N5171B-05

# Modification Available Performance Enhancement Service Note

# N5171B X-Series EXG Analog Signal Generator

The Problem - Self-Test 401 False Failures with Firmware Versions older than B.01.41

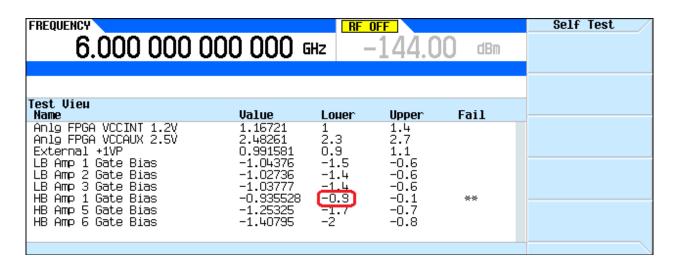
With the release of firmware versions B.01.41 the lower limit for the High Band Amplifier 1 Gate Bias test, which is part of Self-Test 401, was changed from -0.9 to -1.3.

To see what Self-Test limits are being used press **Utility**, **Instrument Info**, **Self Test**, **View Test Info**. Then scroll down to highlight test **401** and press **View Details**. If there are no details available press **Return**, **Run Highlighted** to run that Self-Test, then press **View Details** again. The image below shows the old lower limit of -0.9

Instruments failing the lower limit of Self-Test 401 for the High Band Amplifier 1 Gate Bias test, as shown in the figure above, that have a firmware version older than B.01.41 should be updated with the latest instrument firmware version.
